PEACH BOTTOM ATOMIC POWER STATION, UNIT NO. 2

AMENDMENT TO FACILITY OPERATING LICENSE

Amendment No. 45
License No. DPR-44

SAFETY EVALUATION BY THE OFFICE OF NUCLEAR REACTOR REGULATION

Figure 3.6.1

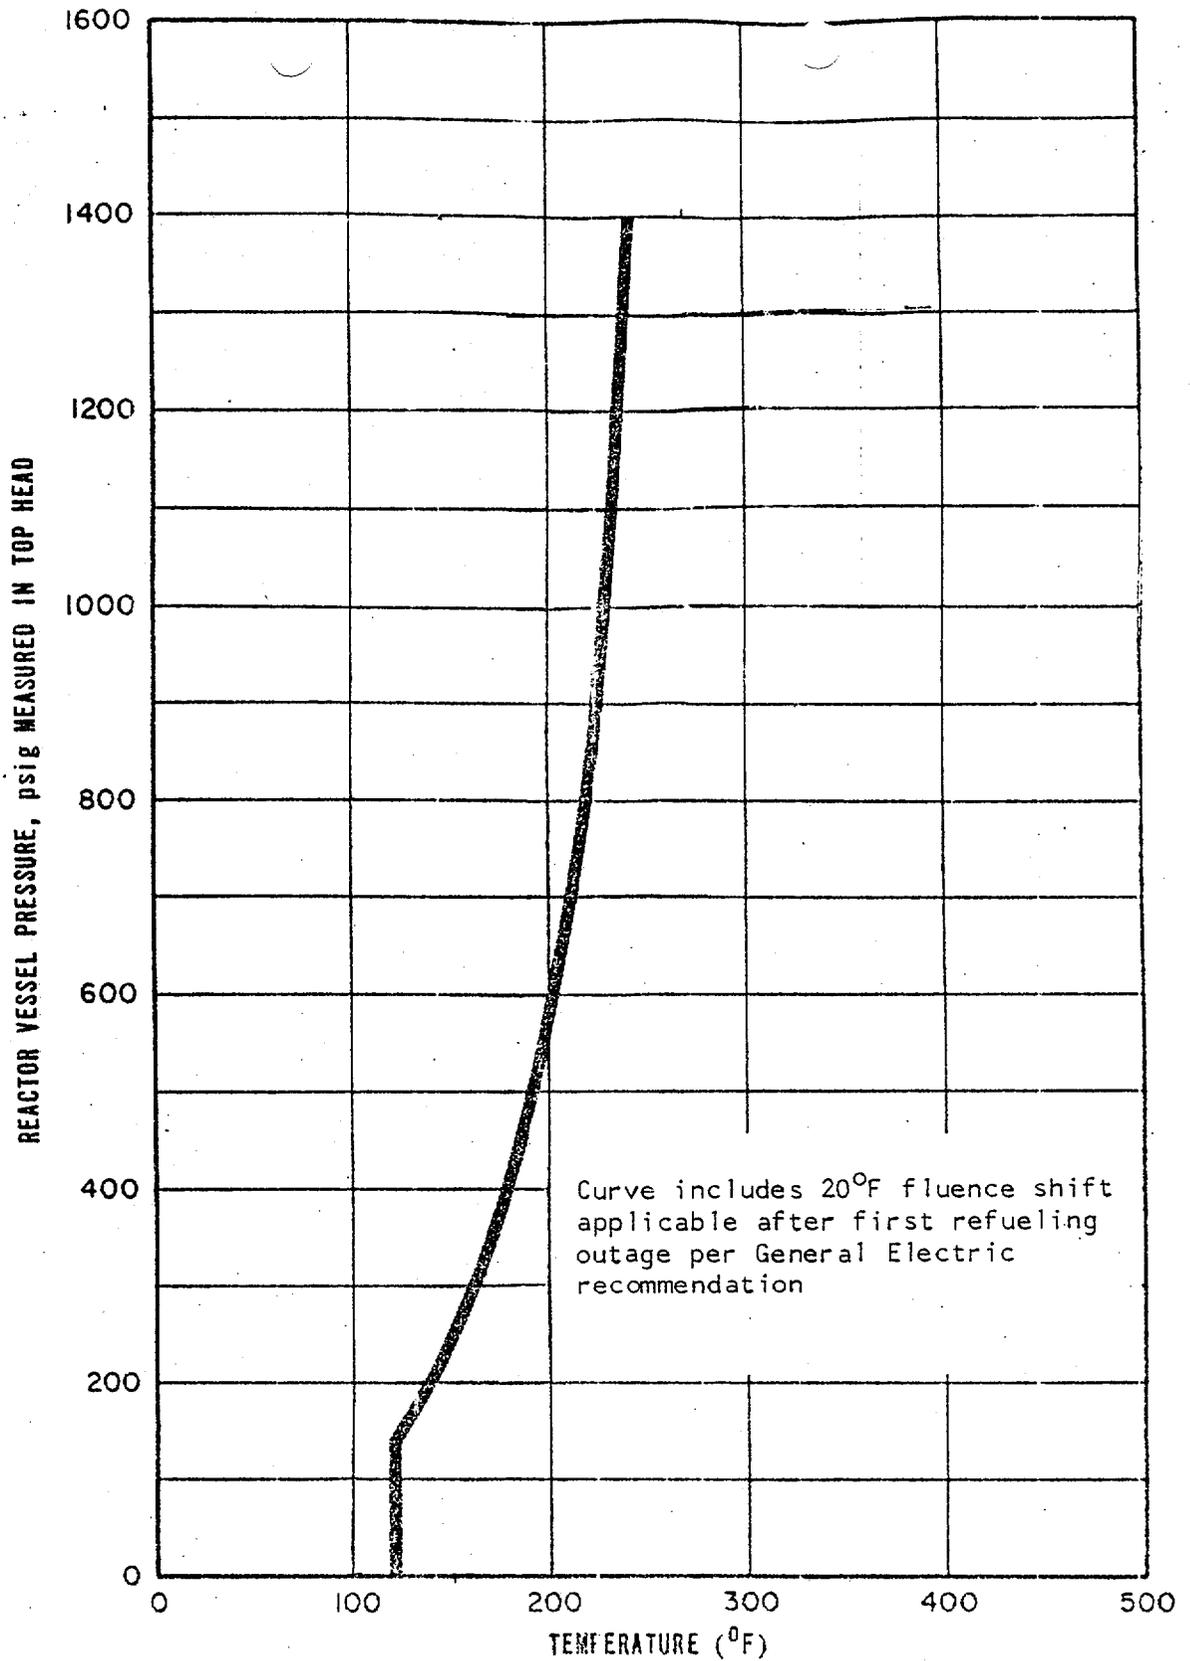
1. The average rate of reactor coolant temperature change during normal heatup or cooldown shall not exceed 100°F increase (or decrease) in any one-hour period.
2. The reactor vessel shall not be pressurized for inservice hydrostatic testing above the pressure allowable for a given temperature by Figure 3.6.1.

Figures 3.6.1, 3.6.2, and 3.6.3 will be updated to account for radiation damage prior to 9 effective full power years of operation.

Figure 3.6.2

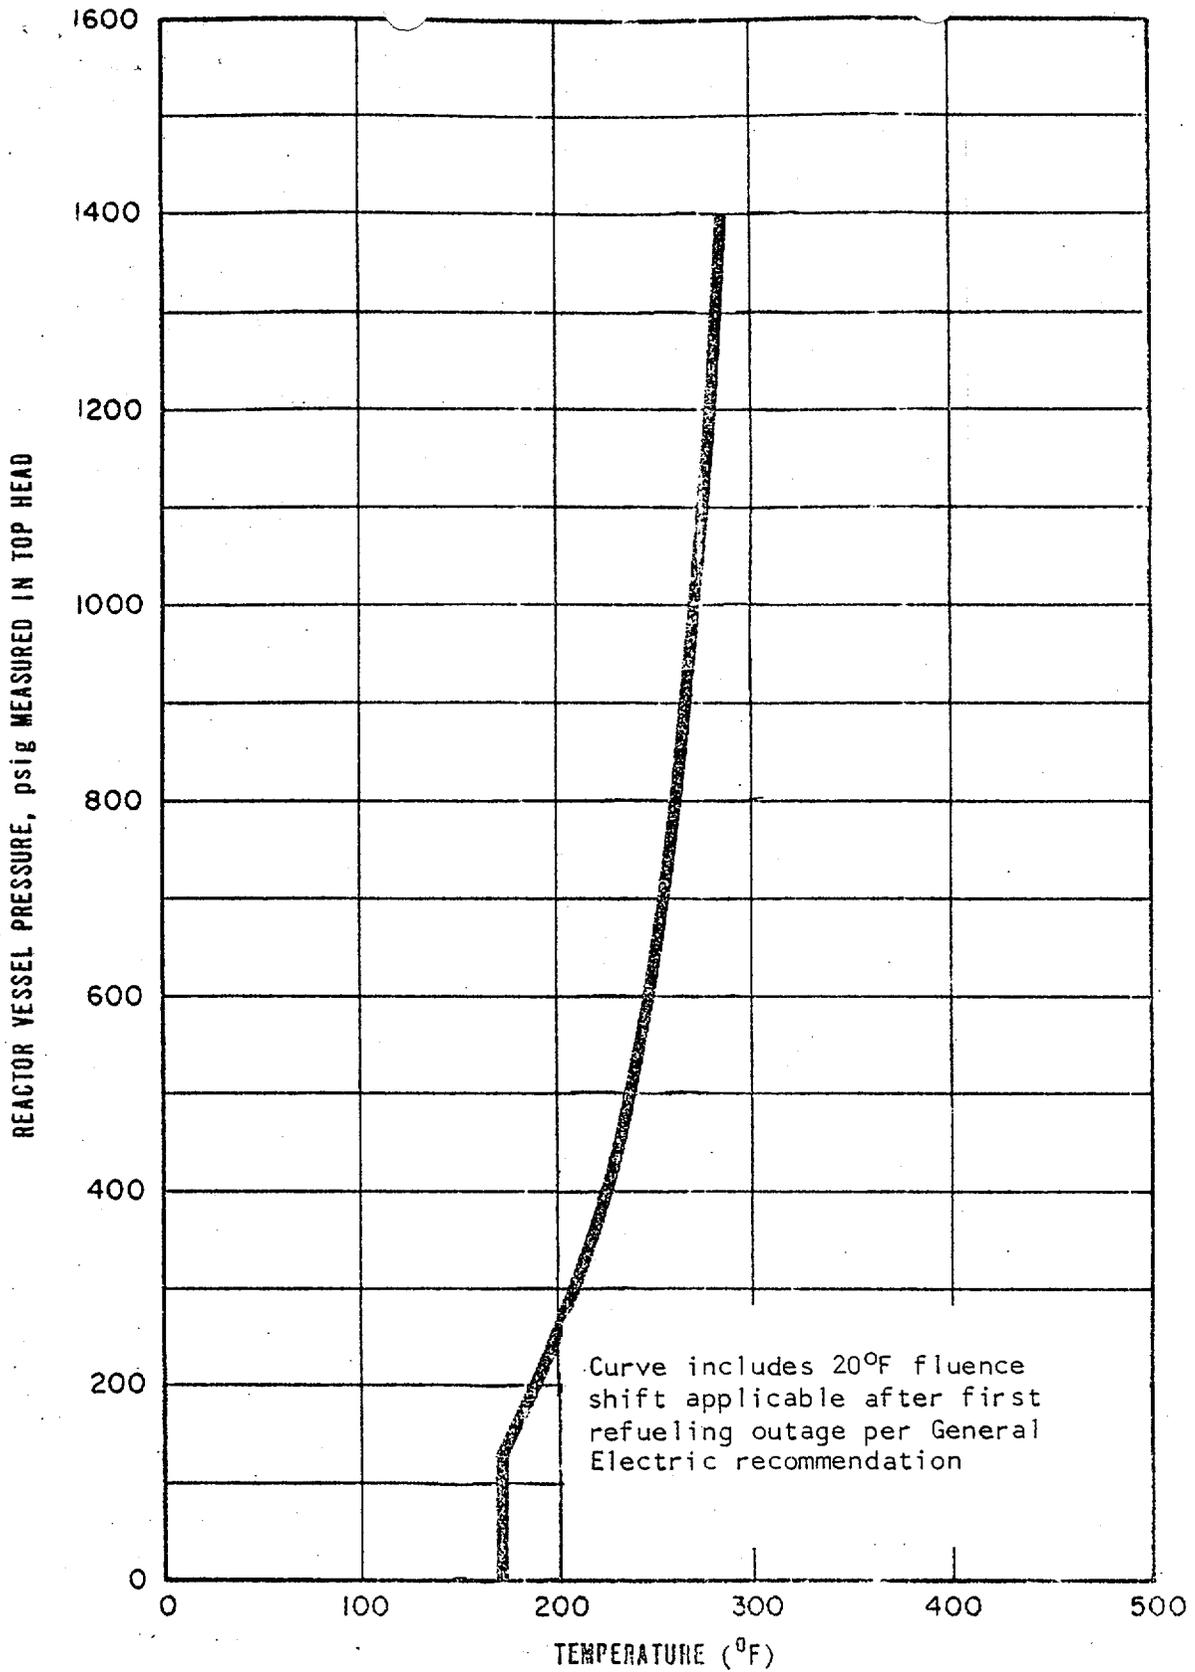
The reactor vessel shall not be pressurized during heatup by non-nuclear means during cooldown following nuclear shut down or during low level physics tests above the pressure allowable by Figure 3.6.2, based on the temperatures recorded under 4.6.A.

Figure 3.6.4

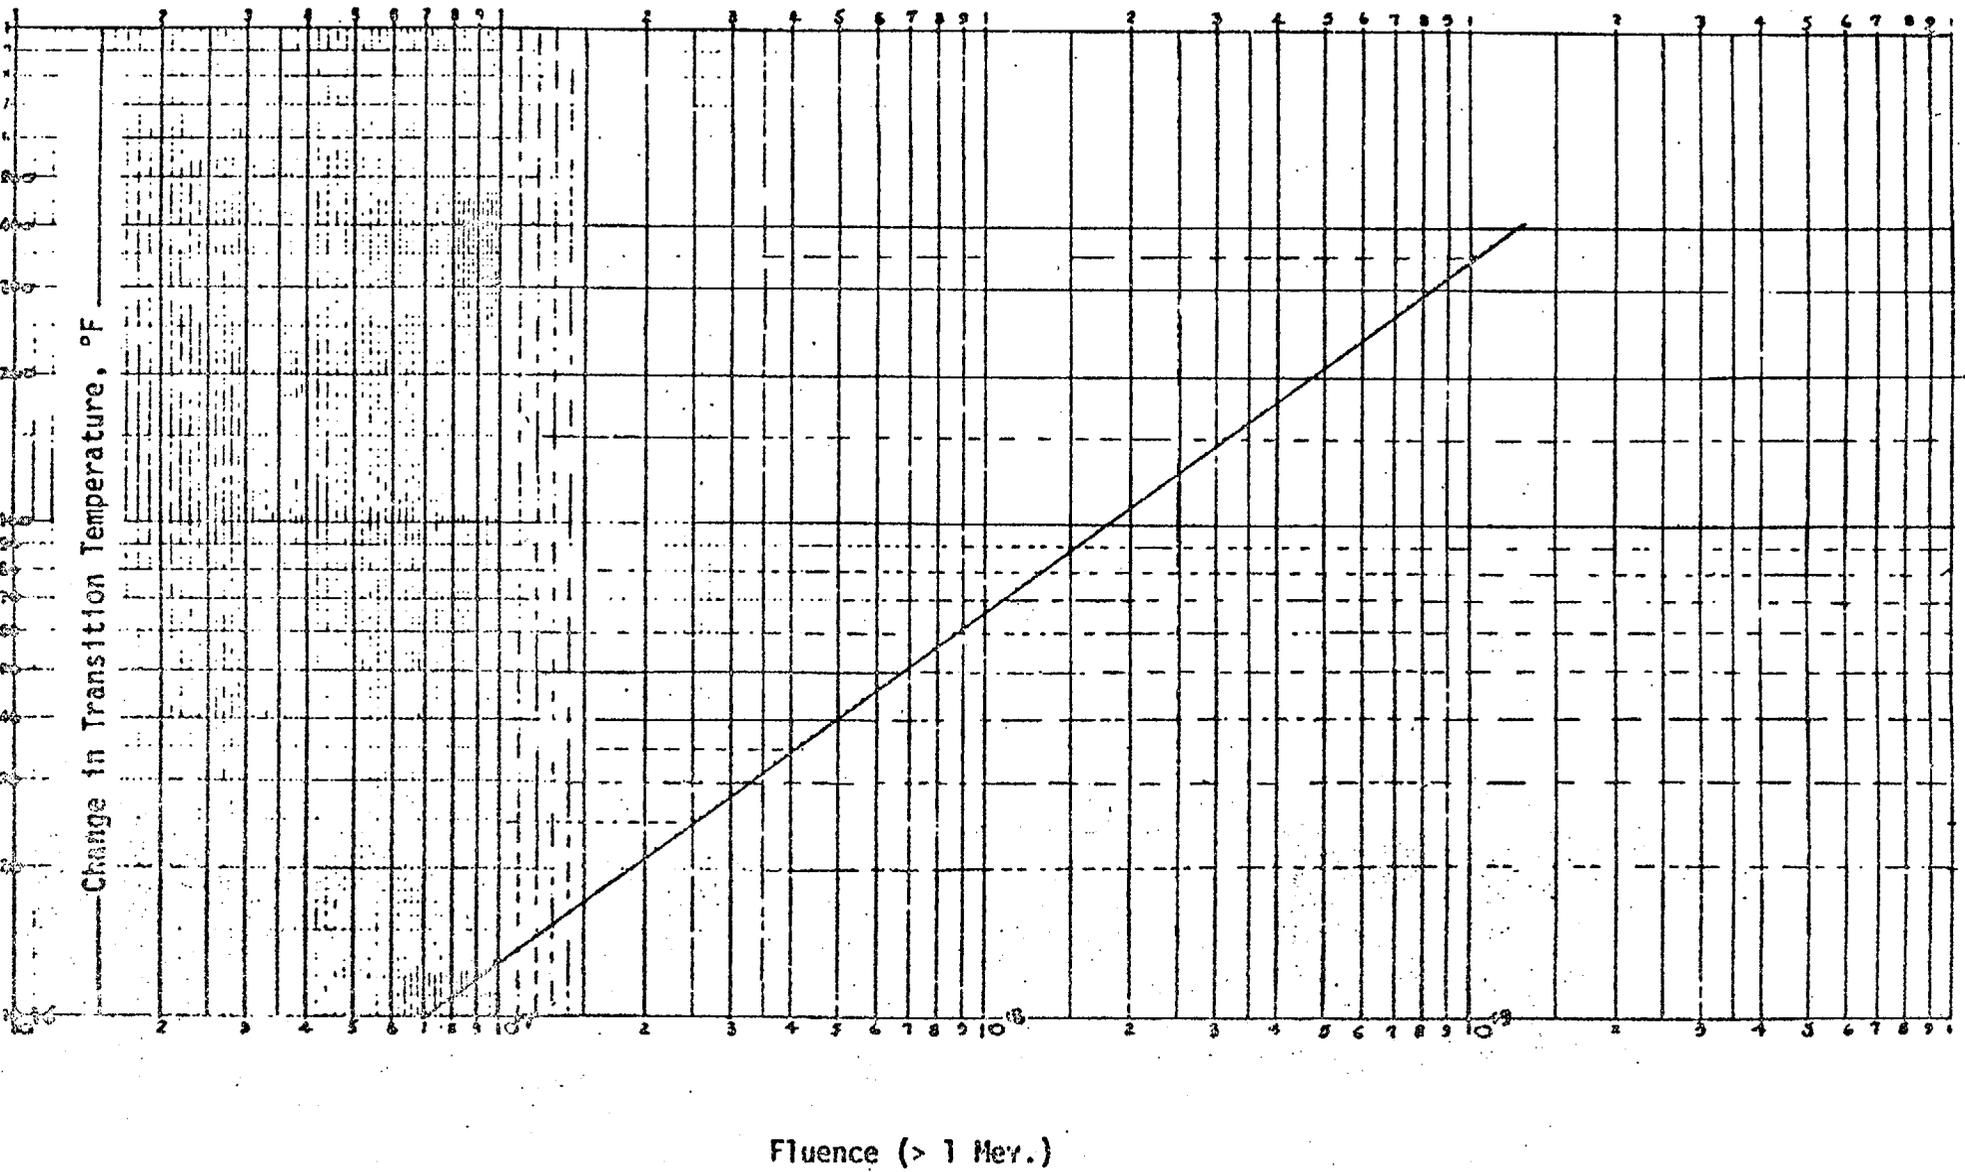
Selected neutron flux specimens shall be removed during the third refueling outage and tested to experimentally verify or adjust the calculated values of integrated neutron flux that are used to determine the RTNDT for Figure 3.6.4.

Neutron flux wires and samples of vessel material are installed in the reactor vessel adjacent to the vessel wall at the core midplane level. The wires and samples will be removed and tested to experimentally verify the values used for Figure 3.6.4.

Figure 3.6.1

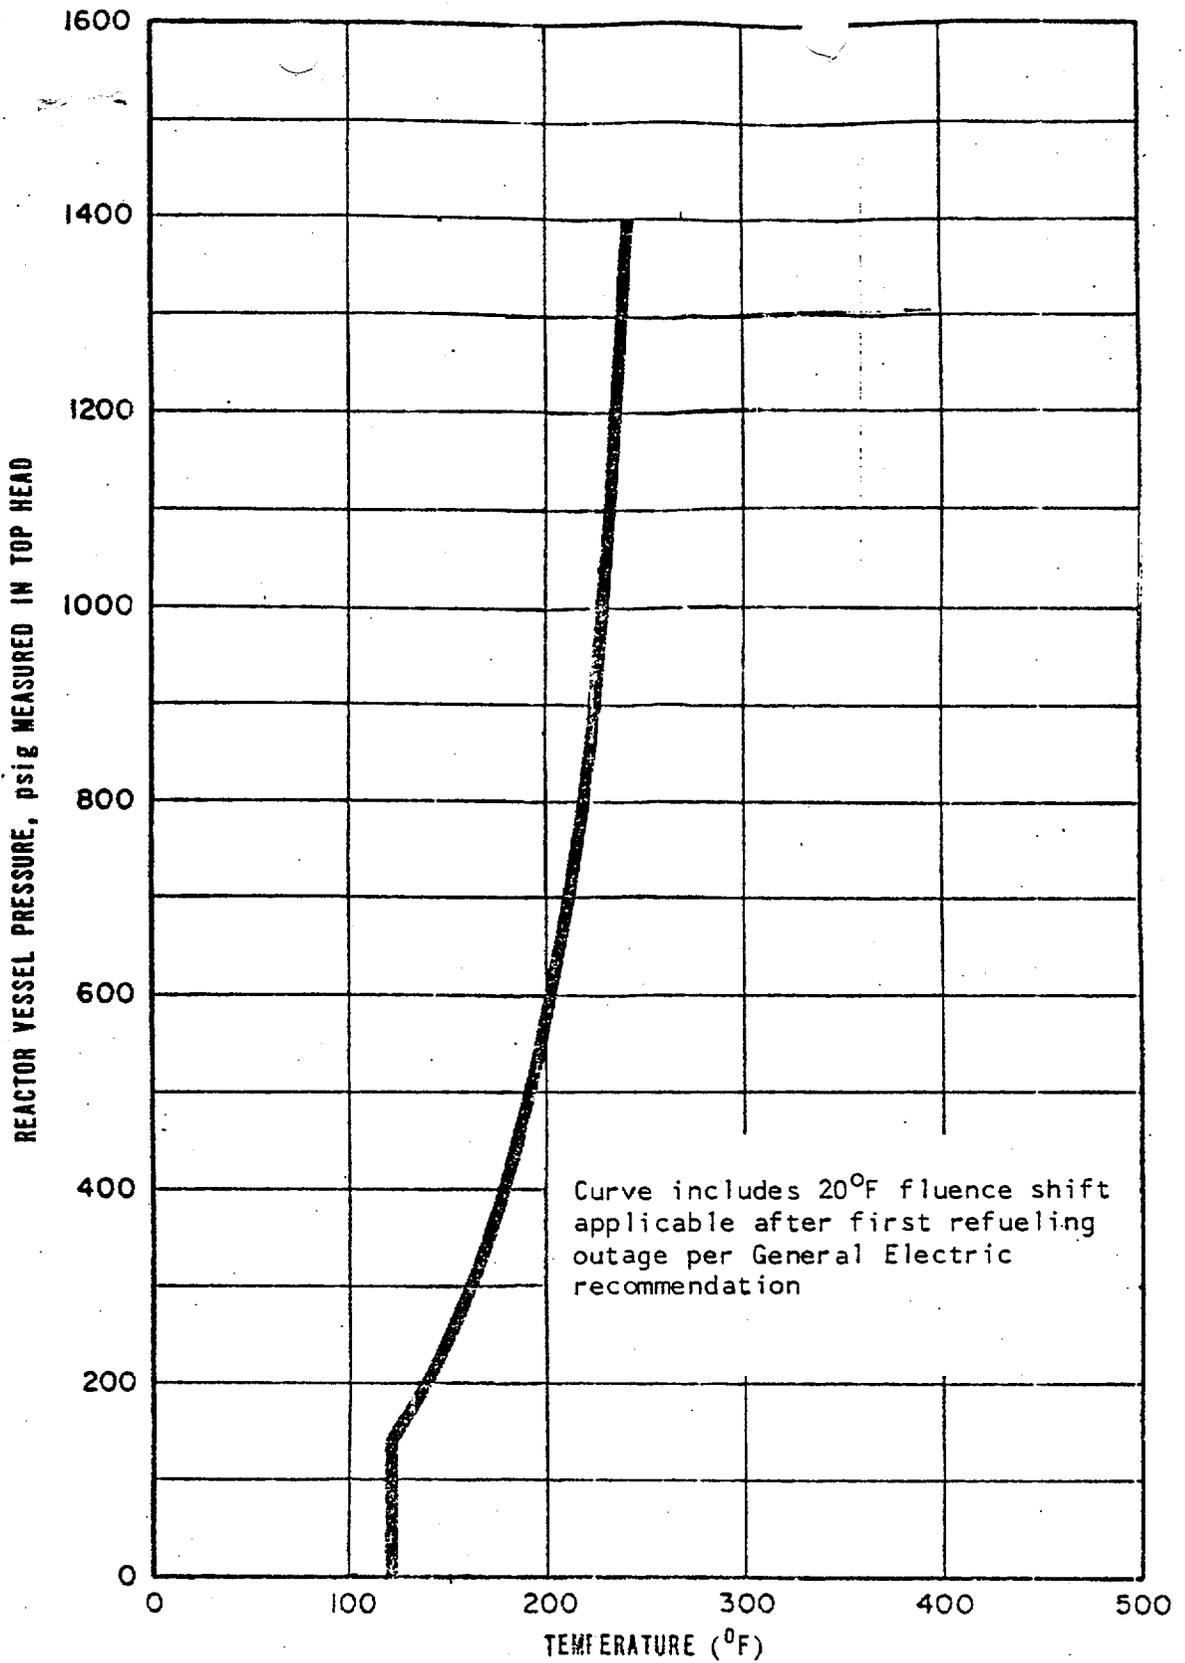
1. The average rate of reactor coolant temperature change during normal heatup or cool-down shall not exceed 100°F increase (or decrease) in any one-hour period.
2. The reactor vessel shall not be pressurized for inservice hydrostatic testing above the pressure allowable for a given temperature by Figure 3.6.1.

Figures 3.6.1, 3.6.2, and 3.6.3 will be updated to account for radiation damage prior to 9 effective full power years of operation.

Figure 3.6.2

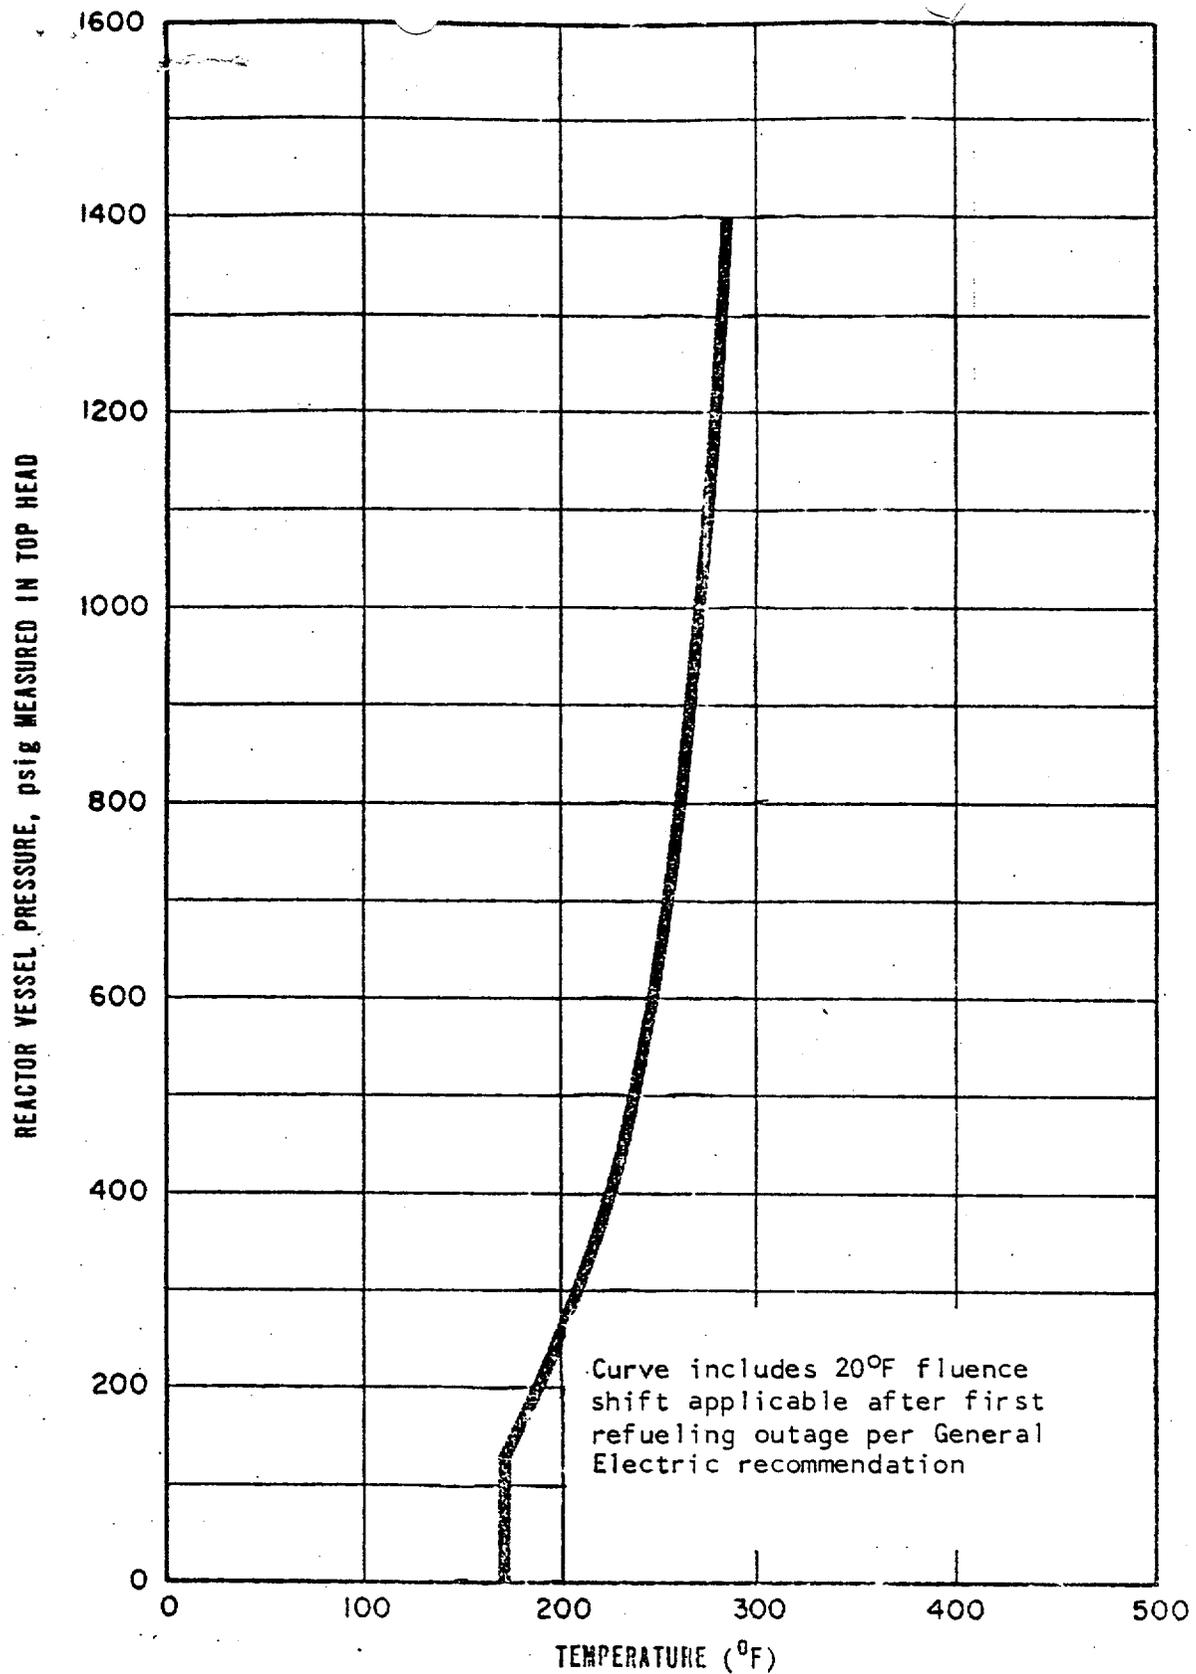
The reactor vessel shall not be pressurized during heatup by non-nuclear means during cooldown following nuclear shut down or during low level physics tests above the pressure allowable by Figure 3.6.2, based on the temperatures recorded under 4.6.A.
